CITY OF ALBUQUERQUE

Re: Approval of Permanent Certificate of Occupancy (C.O.) for

Thomas Bell Community Center, [M-15 / D030]

Re: Thomas Bell Community Center Grades at Handicap Parking

PARTIAL SITE PLAN

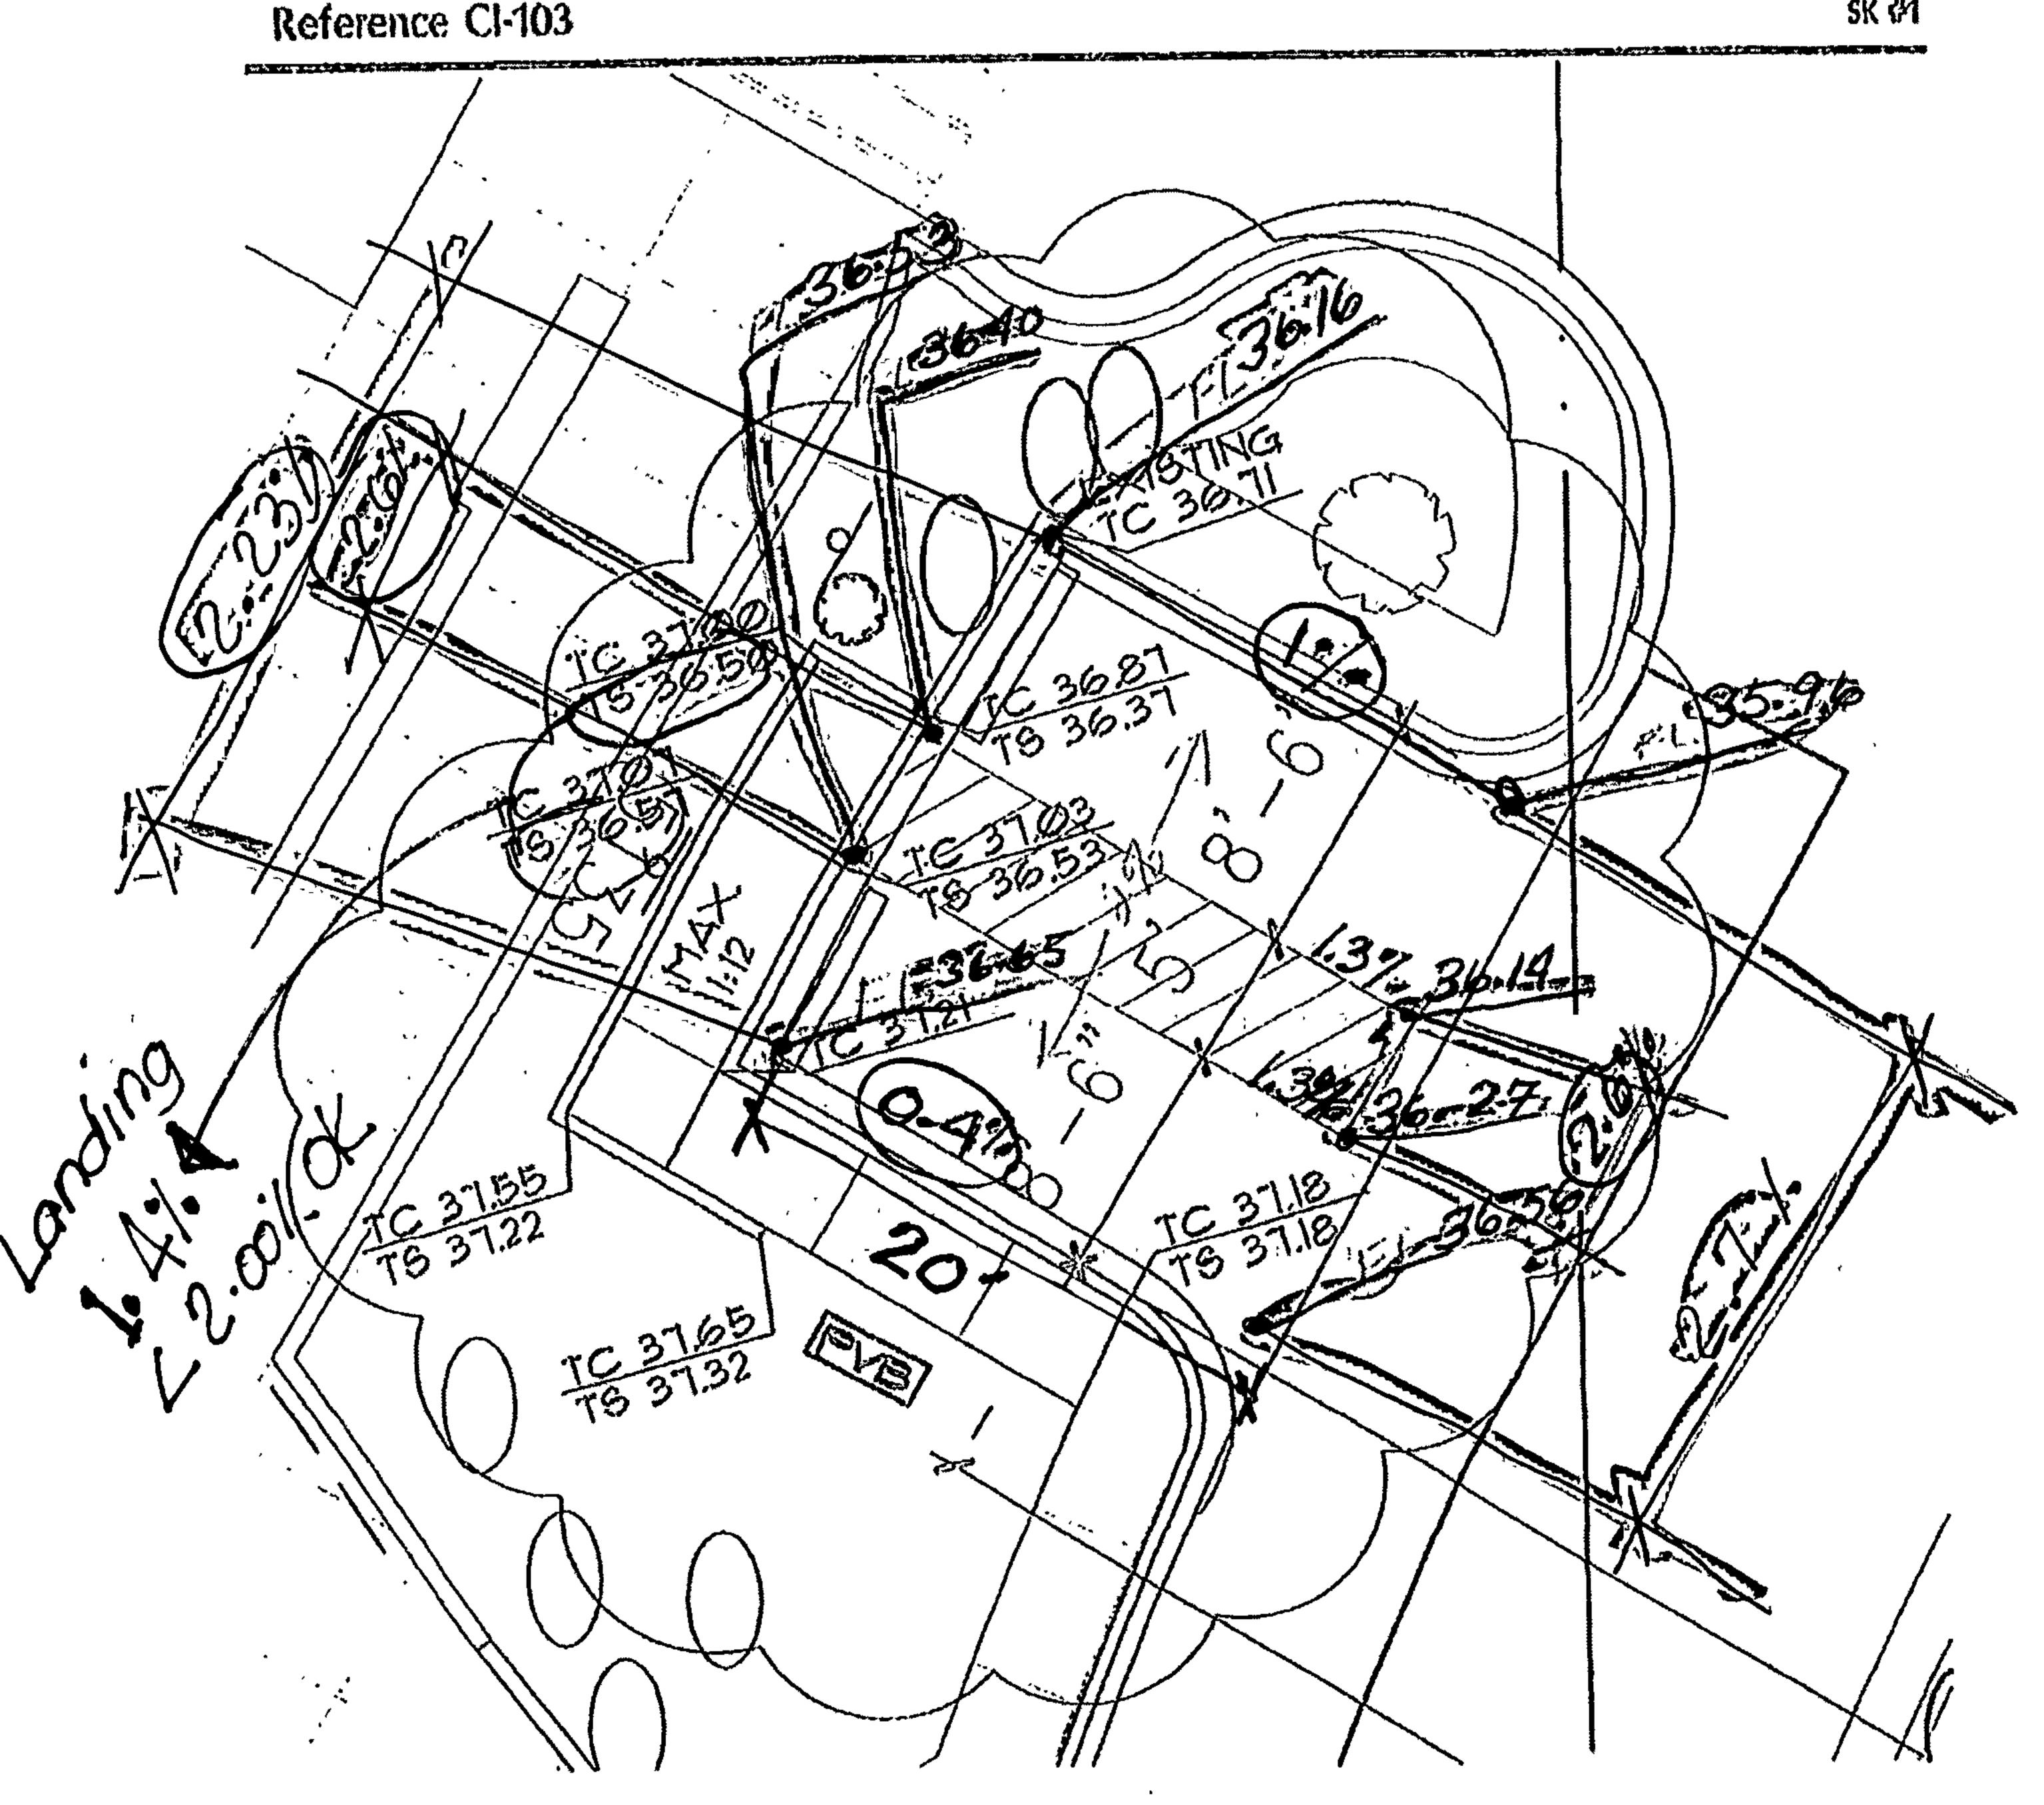
As mentioned in the previous emails from Graeme Means, High Mesa Consulting Group, the grades at the handicap parking lots exceed the 2% slope required by ADA. As you will recall, the site is on a steep hill and the closest existing "level" parking was immediately to the east of front door. After the expansion of the facility, additional handicap parking spaces were required. We proposed using all the parking spaces to the east of the building for this purpose. The existing grades did not meet the 2% slope at that time. Our plans proposed regrading the parking lot and adjacent drive to meet the 2% requirement. During construction and the regrade, we discovered a buried gas line and telephone line preventing us from going the full depth required. The contractor lowered the grade as far as he could, without moving the utilities at great expense to the Owner and managed to meet the existing grades and flatten the parking to meet ADA in some, but not all areas. The steepest cross slope at the handicap parking is 4.8% in one area. See attached grades from the contractor.

NOTE: THESE ARE REGULAR HANDICAP SPACES, PROVIDE APPROPRIATE SIGNAGE.

PARTIAL SITE PLAN

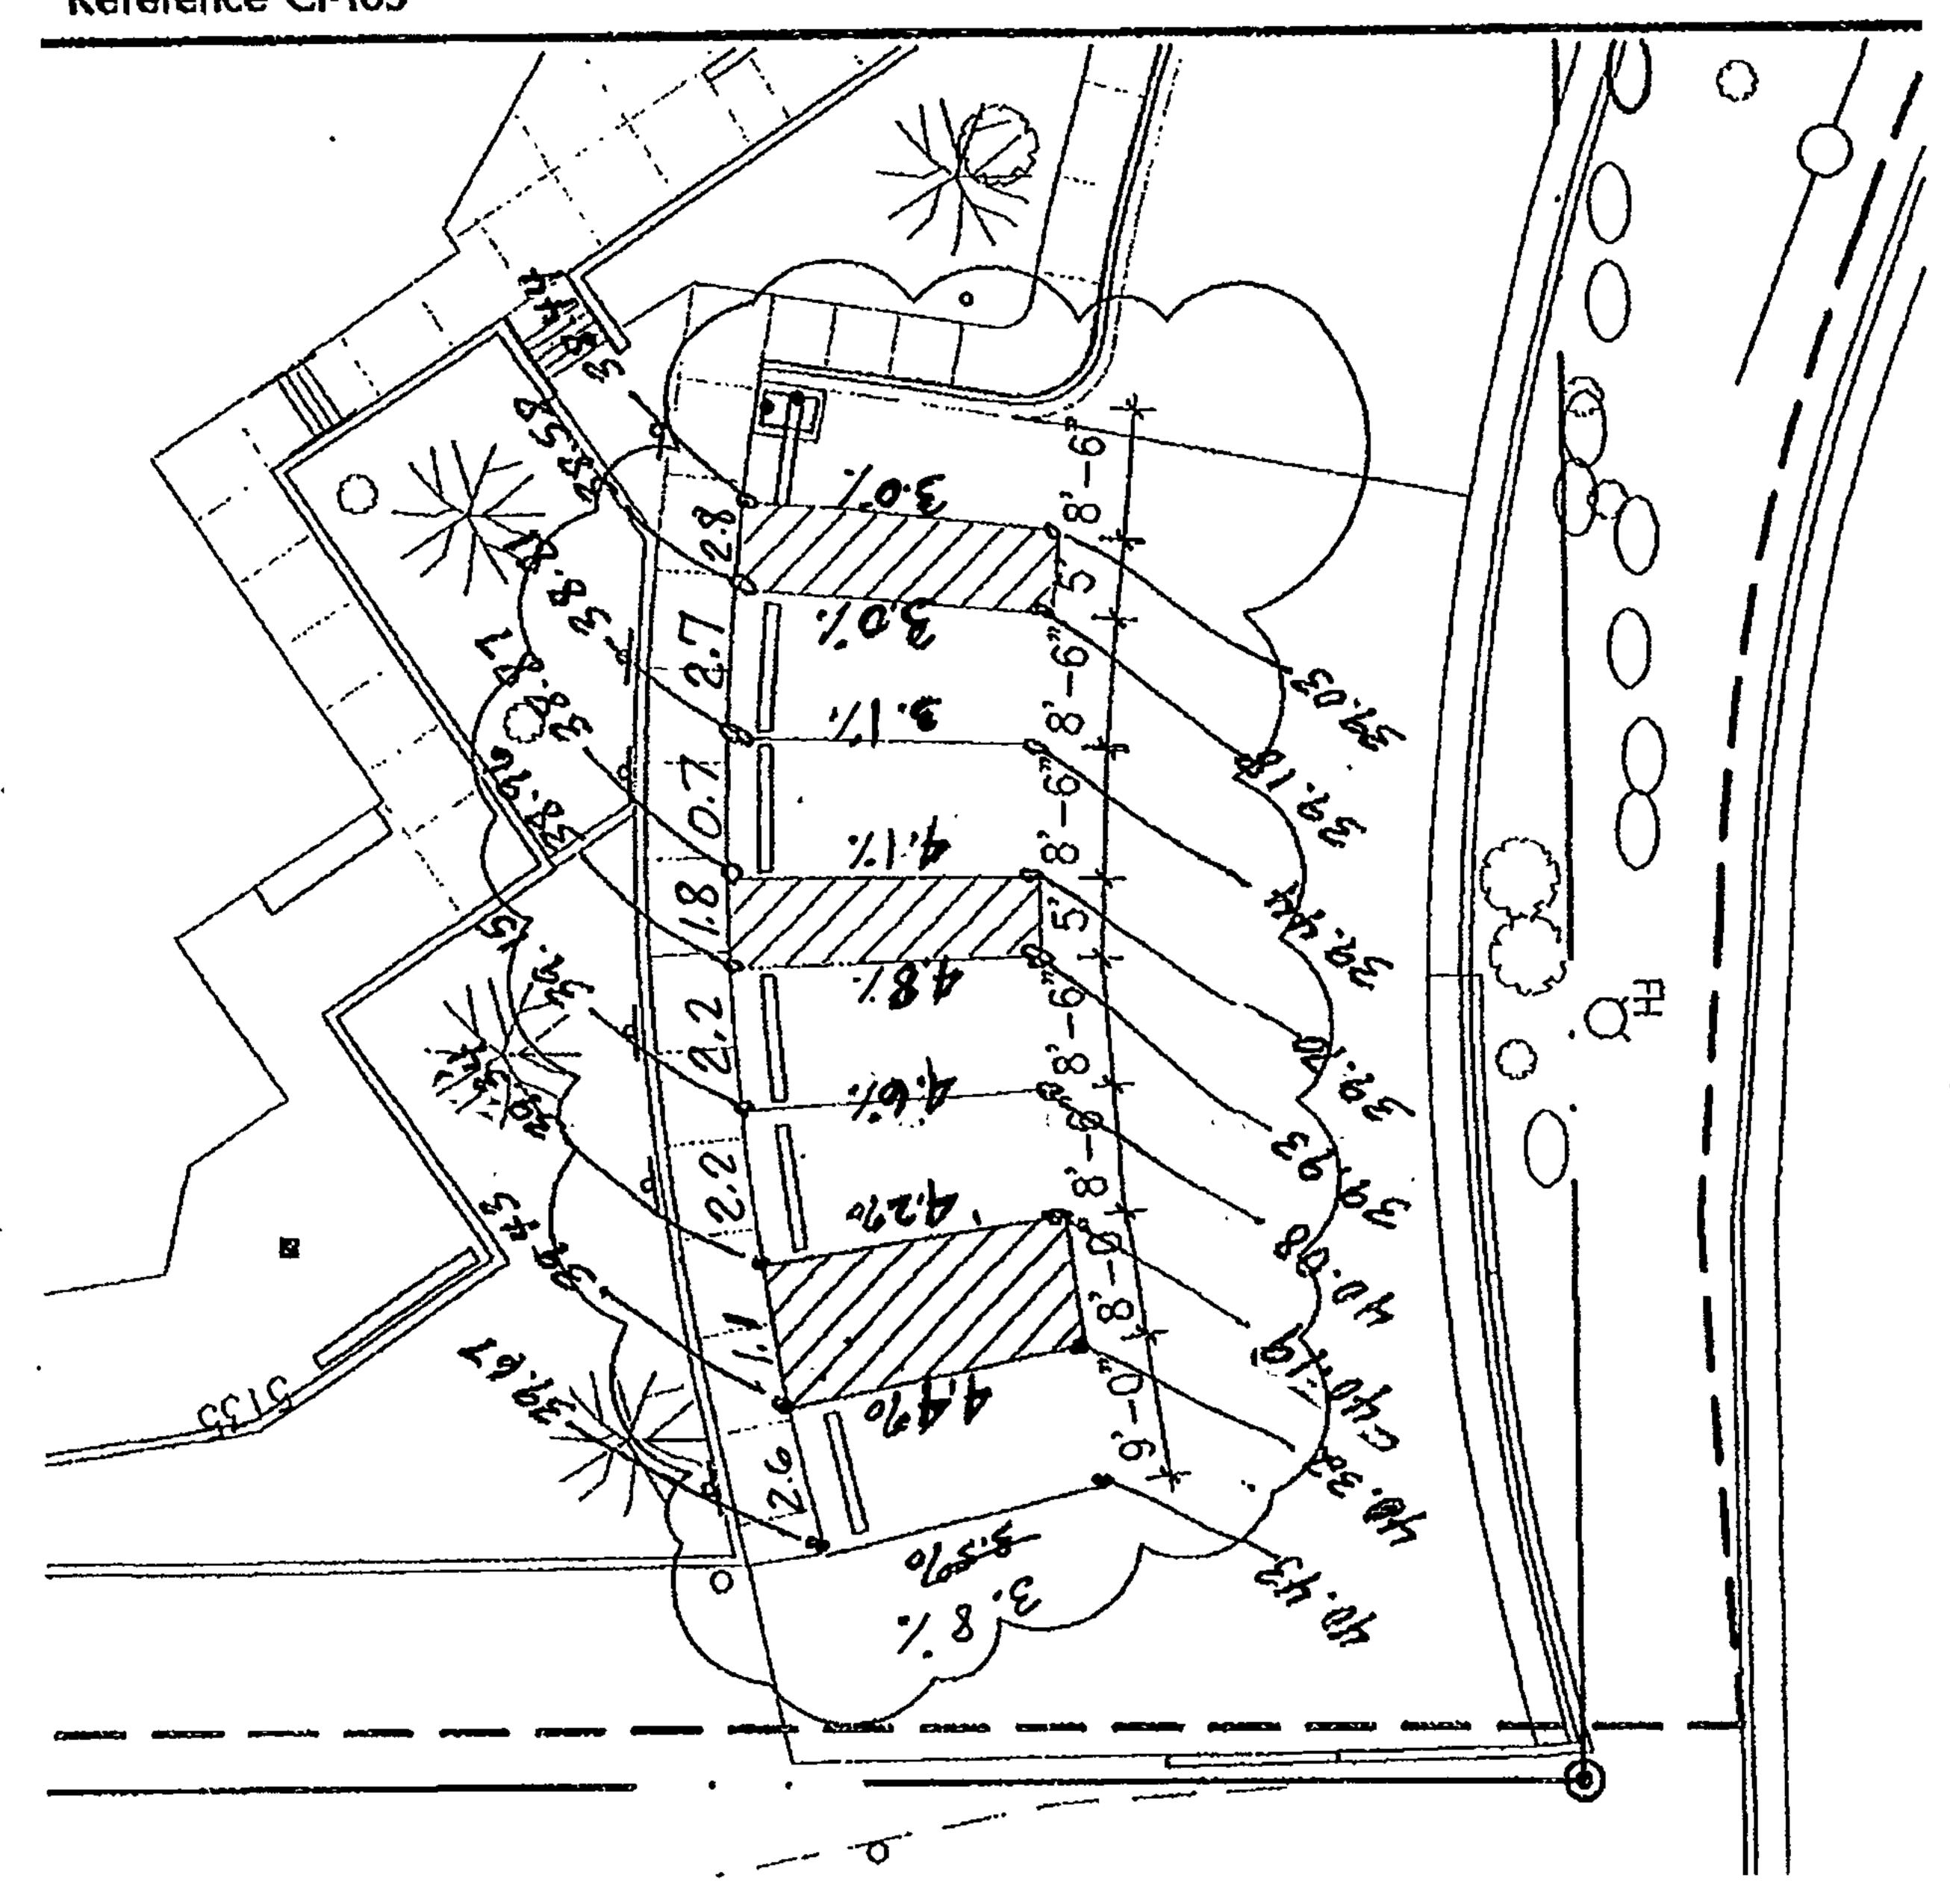
NOTE: HANDICAP PARKING SPACES ARE 8'-6" NOW INSTEAD OF 8'-0" AND VAN ACCESSIBLE SPACE IS 9'-0" WITH 8'-0" AISLE AT SOUTH END. COORDINATE APPROPRIATE SIGNAGE ACCORDING TO SPACES.
